MISSISSIPPI POWER & LIGHT COMPANY

SUBJECT: Grand Gulf Nuclear Station
Units 1 and 2
Docket Nos. 50-416 and 50-417
File 0260/L-334.0/L-350.0
Response to SER Items 1.10(10)
and 1.10(23)
AECM-81/389

Attachment 1: Question and Response 40.40  
SER Item 1.10(23)

Attachment 2: Effects of New Madrid Earthquake & Fault Extension  
SER Item 1.10(10)

Ground Motion and 2% Design Response Spectrum after Newmark and Hall(1978) Recommended Method - 7.3%

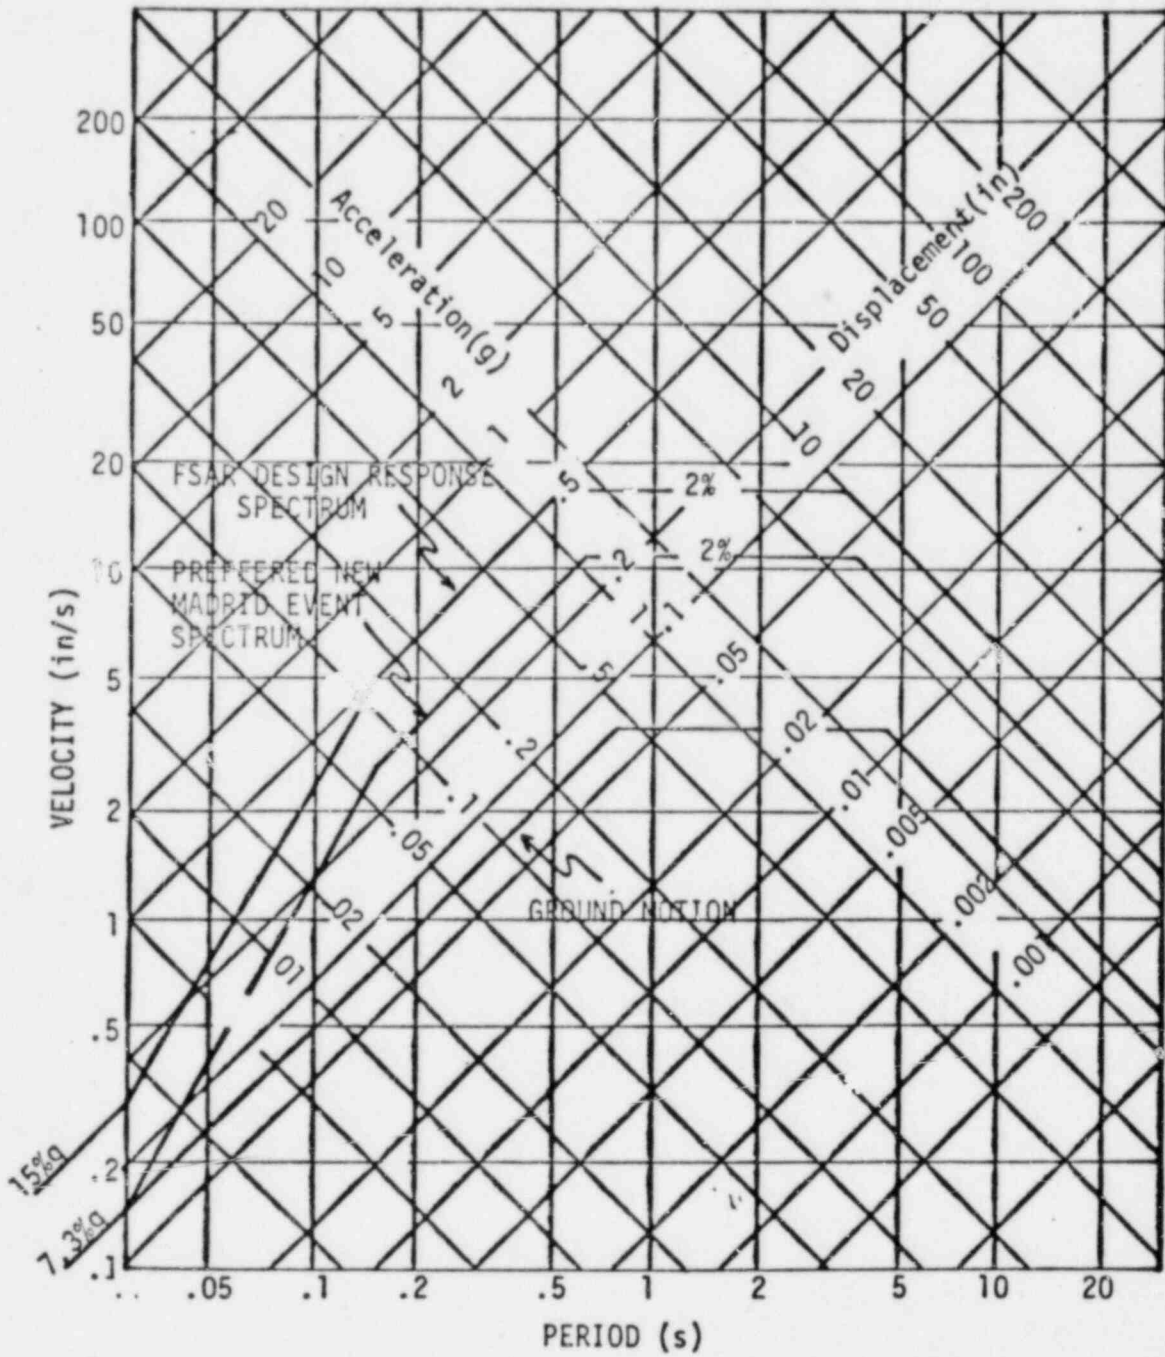
CONCERN: SER Confirmation Issue 1.10(10)

RESPONSE: Design response spectra have been selected assuming a body wave magnitude 7.2 earthquake in the Mississippi Embayment at a distance of 240 km(150 miles) from the Grand Gulf Nuclear Power Plant site. This estimate, and the manner in which it has been made, are discussed briefly below.

The design response spectrum, for two percent critical damping, developed using this method, is attached. The recommended ground motion design values and response spectrum are the lowest and middle curves in this figure, respectively. The design acceleration was derived from a recent graphical representation (Nuttli, 1979) showing sustained horizontal ground acceleration in the central United States. Also shown in this figure is the present Grand Gulf design response spectrum for the same damping value (the uppermost curve shown). As may be seen, this curve envelops the body wave magnitude 7.2 spectrum for all frequencies. Results were found to be comparable at five and seven percent critical damping values.

An alternate approach to design response spectra development was considered. In particular, peak acceleration and velocity values derived from studies of central United States strong ground motion attenuation (Nuttli, 1979; Herrmann, 1981) were also used to scale spectral amplification factors. The results of this approach were found to be comparable to the first approach for frequencies greater than two cycles per second, but generally exceeded current Grand

Gulf design response spectra for lower frequencies. This alternate approach, and the results, are qualitatively consistent with the current NRC staff position as noted in the Grand Gulf SER (U.S. Nuclear Regulatory Commission, 1981).

In conclusion, a recommended design response spectrum at Grand Gulf from a body wave magnitude 7.2 earthquake at a distance of 240 km is attached. This and the NRC staff estimates are in close agreement for higher frequencies. Divergence of the estimates occurs for frequencies less than two cycles per second. Detailed review of Grand Gulf structures indicates that the lower frequencies are not important to evaluation of project structural responses.
